5.6 T220321 PA - Construction of Twenty-Six (26) Dwellings, Removal of Native Vegetation and Reduction in Car Parking Requirements at Lot H PS400130, Princes Highway, Pakenham VIC 3810

APPLICATION NO.:	T220321 PA
APPLICANT:	Pakenham Property Holdings Pty Ltd
LAND:	LH PS400130, Princes Highway, Pakenham VIC 3810
PROPOSAL:	Construction of Twenty-Six Dwellings (26), Removal of Native Vegetation and Reduction In Car Parking requirements.
PLANNING CONTROLS:	<ul style="list-style-type: none"> • Mixed Use Zone – Schedule • Land adjacent to the Principal Road Network (Transport 2 Zone) • Development Contributions Plan Overlay Schedule 1
NOTIFICATION & OBJECTIONS:	The application was put on public notice in accordance with Section 52 of the Planning and Environment Act. Notices were sent to neighbouring properties and signage erected on-site for fourteen (14) days. No objections have been received to date.
KEY PLANNING CONSIDERATIONS:	<ul style="list-style-type: none"> • Detailed design standards for internal amenity and safety • Interface with adjoining land uses • Integration with streetscape and neighbourhood character • Detail of assessment to support native vegetation removal • Car pa

Figure 1 - Site Plan showing the southern portion of the site in red, and the historically permitted but not constructed (and expired) service station to the north.

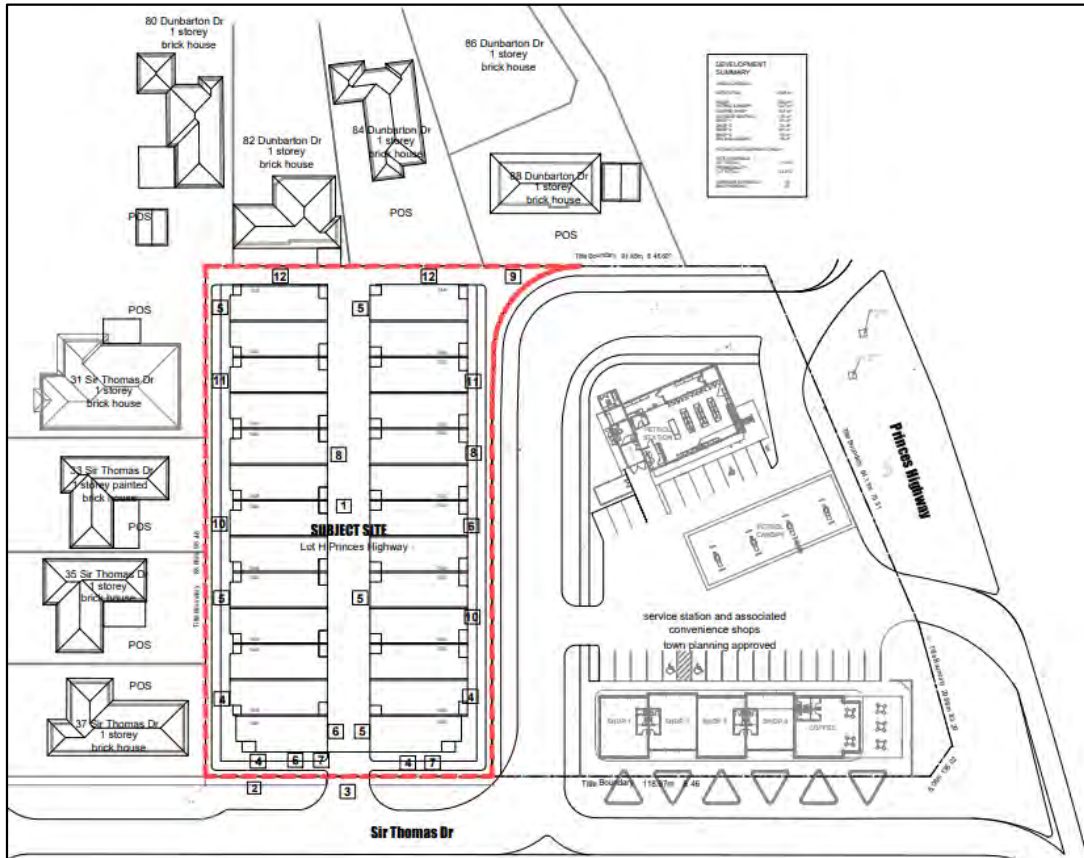
Each three-bedroom dwelling is provided with two (2) garaged car parking spaces meeting the requirement of Clause 52.06-5. However, a twenty-six (26) townhouse development requires five (5) visitor car parking spaces to be provided.

The development proposes only two (2) visitor car parking spaces within the setback to Sir Thomas Drive, and the application seeks for a dispensation to allow for a shortfall of three (3) spaces.

Figure 2 - Ground floor of southern flank of townhouses (Townhouses No. 1-13)

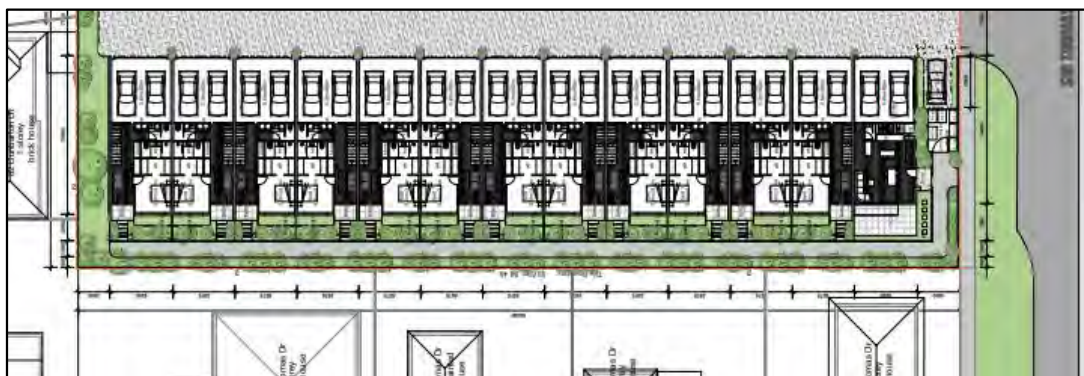
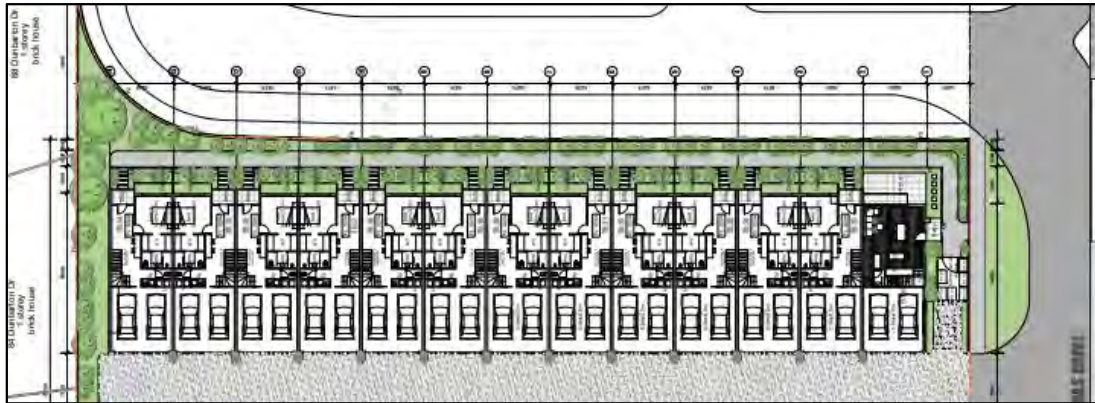
- The two ~80m long pedestrian pathways are not supported as they do not provide safe, adequate or functional access to the dwellings. The location of the pathway close to the southern boundary also reduces landscape potential to reduce any bulk and massing concerns when the site is viewed from the south.

- The dwellings lack meaningful diversity in layouts/number of bedrooms.
- The lack of articulation and capacity for meaningful landscaping within the central driveway area does not result in an appropriate planning outcome.

- 24 of 26 dwellings rely on balconies to provide secluded private open space, but do not allow for appropriate views or a sense of spaciousness due to overlooking of the internal driveway and 'rear' of the northern flank of dwellings, or would otherwise overlook a service station (if constructed). If the service station is not constructed, the northern dwellings have screened balconies for limited reasons.
